**Flood Control Project Maintenance
Levee Inspections**
LMA District Cover Sheet
Spring 2015 Levee Inspection Results

Reclamation District No. 0765 Glide

Levee Inspection Report By Mile - Spring 2015

Waterway	Bank	Unit Miles	Inspection Start/End	Inspector
Unit No. 01 Sacramento River	Right	1.72	04/23/2015 04/23/2015	Richard Willoughby

Photo 1 of 6 : SP_2015_RD0765_211_17_20150309_00019.jpg

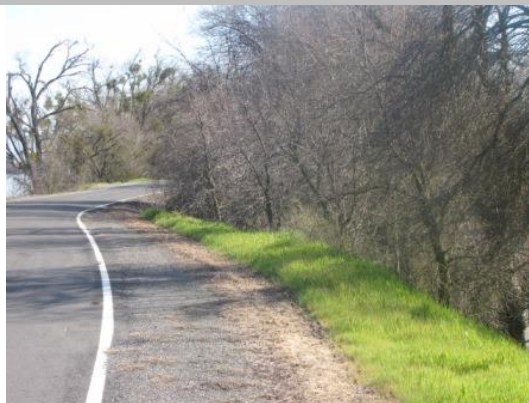
LM Start	0.86	Rating **	A/W	Issue No.	17
LM End	0.98	Issue Type +	Ma	Location *	LS
Category	Earthen Levee			GPS Latitude/Longitude	
				Start	End
Item	Trim / Thin Trees			38.491283 °	38.489771 °
				-121.556360 °	-121.555451 °
DWR ID	DWR_RD0765_01_s _ 2012_17				
Action/Comments					
Trim trees to at least five feet above ground level.

Photo 2 of 2 : SP_2015_RD0765_211_6_20150309_00008.jpg

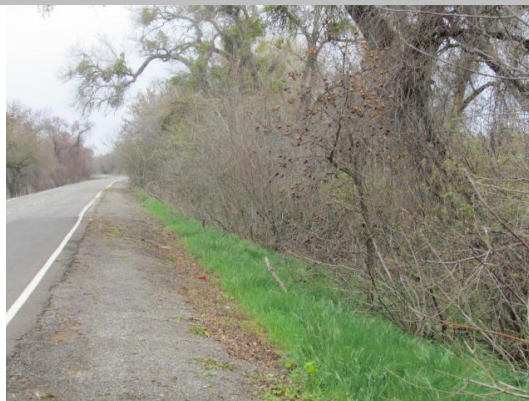
LM Start	0.98	Rating **	A/W	Issue No.	6 (cont)	
LM End	1.14	Issue Type +	Ma	Location *	WS	
Category	Earthen Levee			GPS Latitude/Longitude		
				Start		End
Item	Trim / Thin Trees			38.489664 °	38.487617 °	
				-121.555370 °	-121.554200 °	
DWR ID	DWR_RD0765_01_f_2012_6					
Action/Comments						
Trim trees to at least five feet above ground level.

Photo 1 of 4 : SP_2015_RD0765_211_37_20150309_00042.jpg

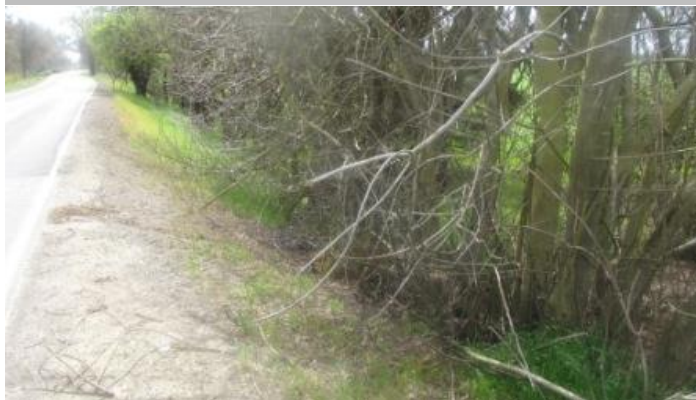
LM Start	1.07	Rating **	A/W	Issue No.	37
LM End	1.07	Issue Type +	Ma	Location *	LS
Category	Earthen Levee			GPS Latitude/Longitude	
				Start	End
Item	Trim / Thin Trees			38.488503 °	38.488503 °
				-121.554757 °	-121.554757 °
DWR ID	DWR_RD0765_01_s_2012_37				
Action/Comments					
Trim and thin trees to allow visibility of the ground and room to flood fight.

Photo 2 of 4 : SP_2015_RD0765_211_37_20150309_00043.jpg

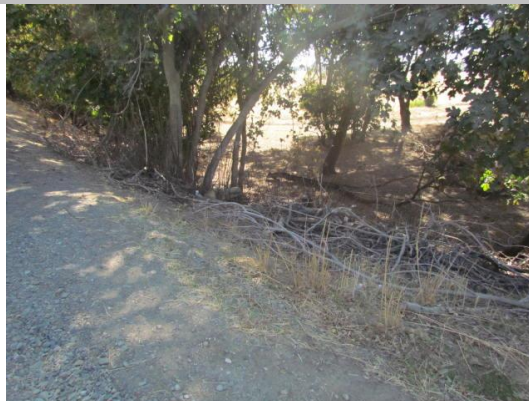
LM Start	1.07	Rating **	A/W	Issue No.	37 (cont)
LM End	1.07	Issue Type +	Ma	Location *	LS

Photo 1 of 2 : SP_2015_RD0765_211_53_20150309_00055.jpg

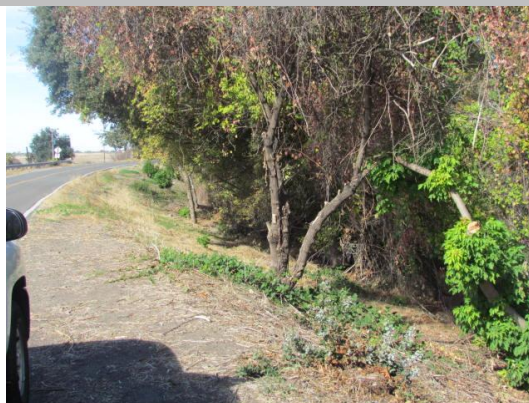
LM Start	1.66	Rating **	A/W	Issue No.	53
LM End	1.67	Issue Type +	Ma	Location *	WS
Category	Earthen Levee			GPS Latitude/Longitude	
				Start	End
Item	Trim / Thin Trees			38.480892 °	°
				-121.549654 °	°
DWR ID	DWR_RD0765_01_s_2013_53				
Action/Comments					
Trim trees to at least five feet above ground level.

Photo 2 of 2 : SP_2015_RD0765_211_52_20150309_00054.jpg

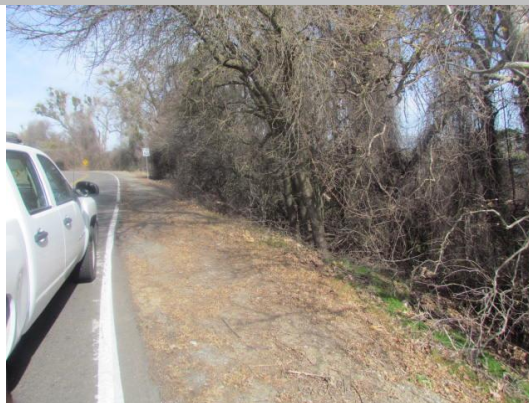
Looking north (upstream) at dense trees on landside slope.
